**Re: Waste Licence Application W0231-01**

**Fingal Landfill**

**Submission to the Re-Opened EPA Oral Hearing**

**27<sup>th</sup> April, 2009**

**Figure 8** Fingal Landfill  
**BRC2 (Shallow Bedrock) Groundwater Level (mAOD)**

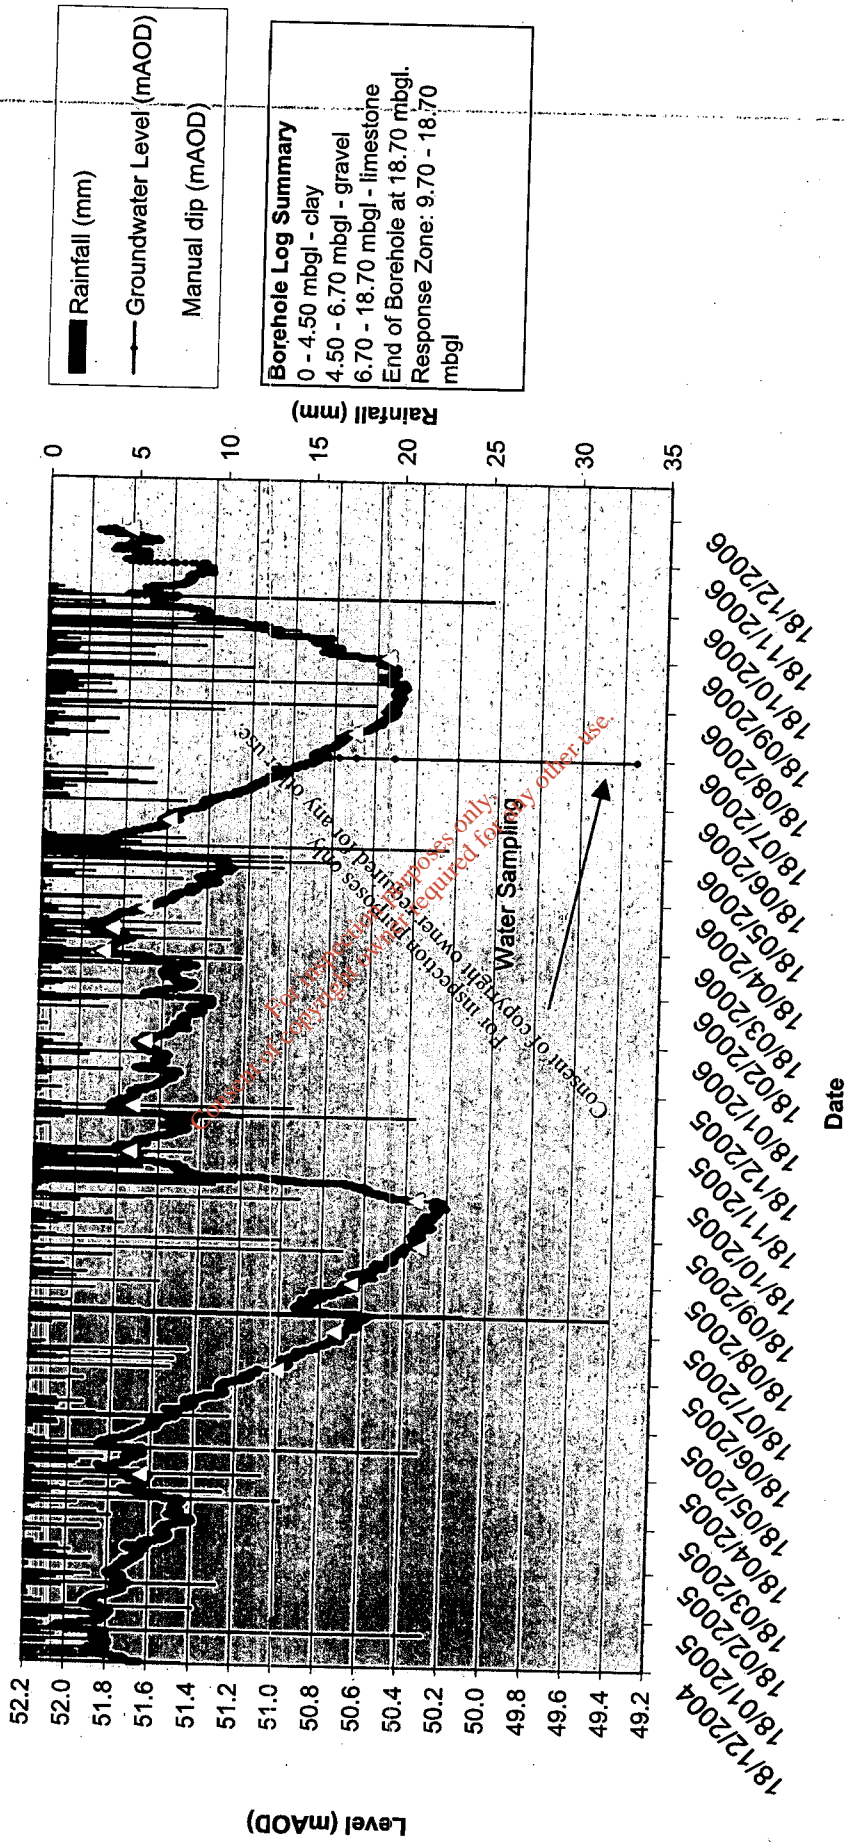
It is clear from a comparison of the hydrographs from monitoring wells BSA4 (within the footprint) and BRC2 (Figure 8) and which are located in the clay overburden and the bedrock respectively that both are part of a single and continuous groundwater system. The hydrographs show an identical pattern of recharge and discharge with both the clay overburden and the underlying bedrock receiving recharge in wet periods and discharging to the local drainage network in drier periods.

To suggest that these two groundwater systems are either separated physically or hydraulically is in my opinion contrary to all the information that the Applicant has so far placed in the public domain. The Applicant is therefore beheld to present the Agency with the field data that demonstrates the correctness of the Applicant's alternative assertion that these two groundwater bodies are;
